Amendments to the Drawings:

FIG. 4A

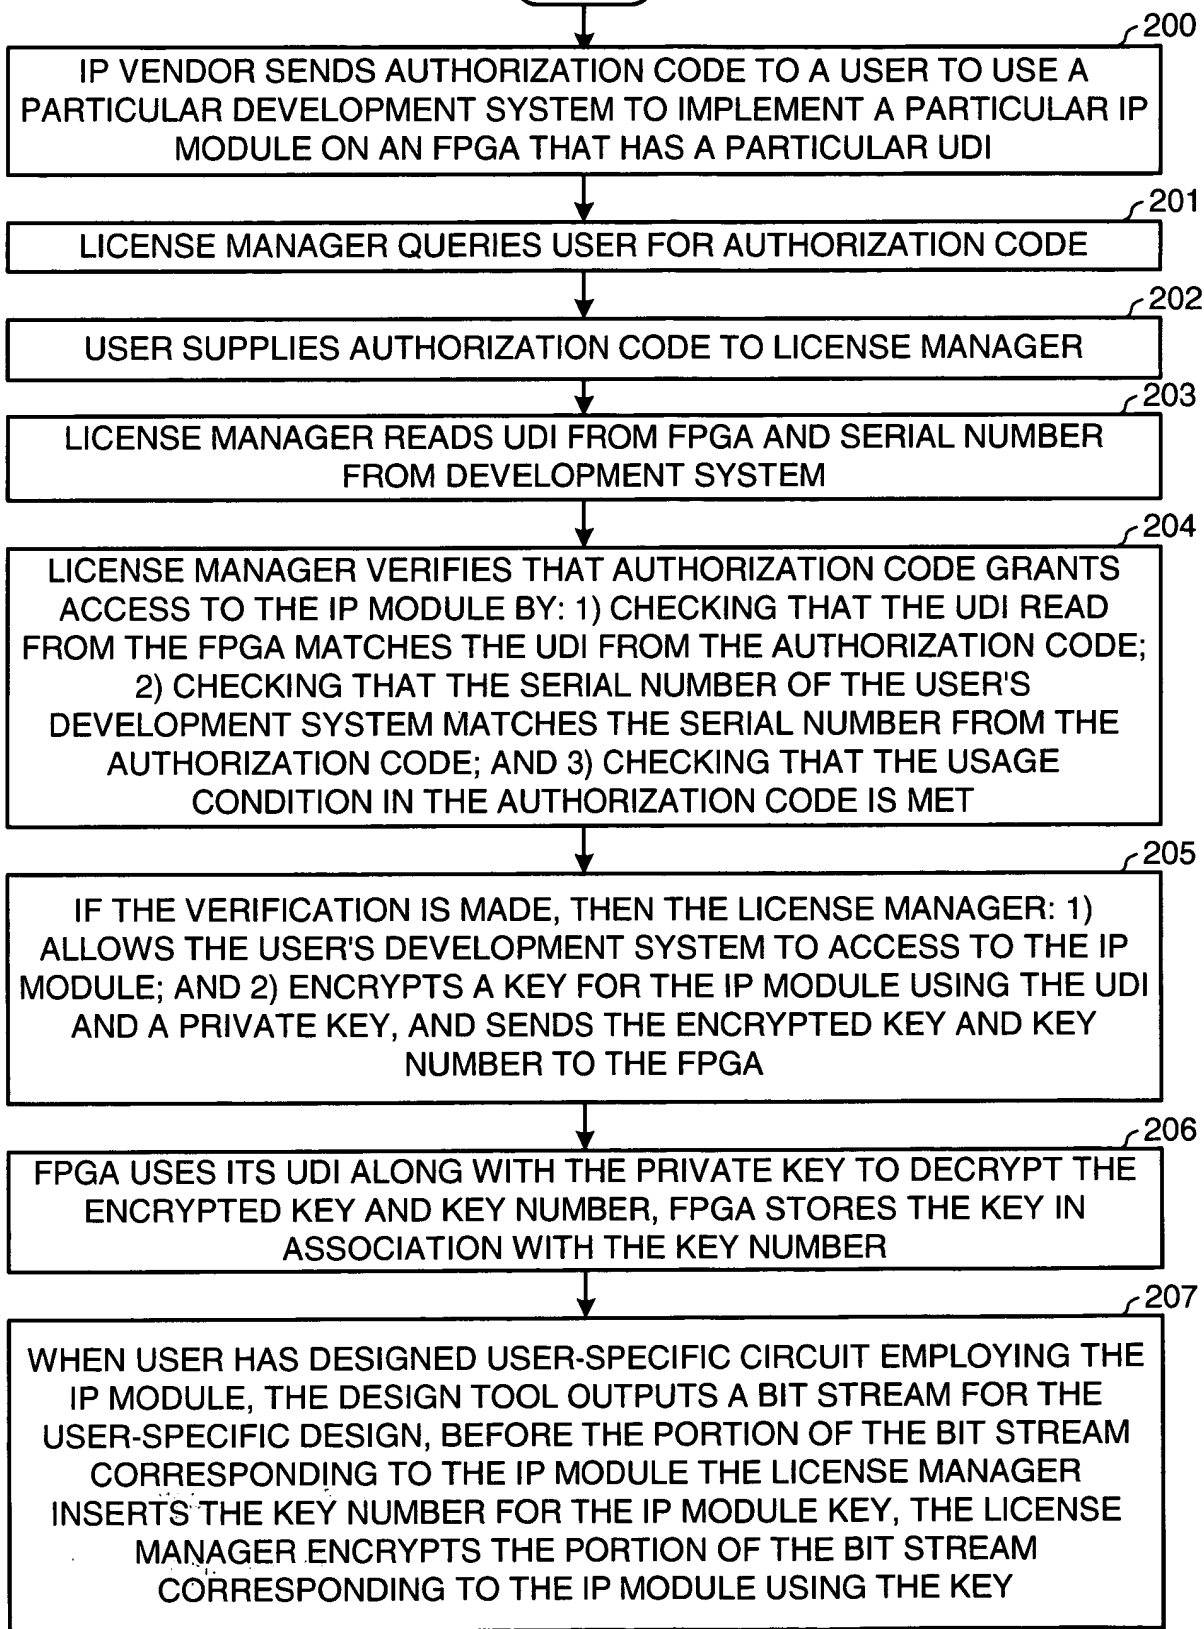
Please amend Figure 4A by amending the text in block 204 as follows.

LICENSE MANAGER VERIFIES THAT AUTHORIZATION CODE GRANTS ACCESS TO THE IP MODULE BY: 1) CHECKING THAT THE UDI READ FROM THE FPGA MATCHES THE UDI FROM THE AUTHORIZATION CODE; 2) CHECKING THAT THE SERIAL NUMBER OF THE USER'S DEVELOPMENT SYSTEM MATCHES THE SERIAL NUMBER FROM THE AUTHORIZATION CODE; AND 3) CHECKING THAT THE USAGE CONDITION IN THE [[UDI]] AUTHORIZATION CODE IS MET
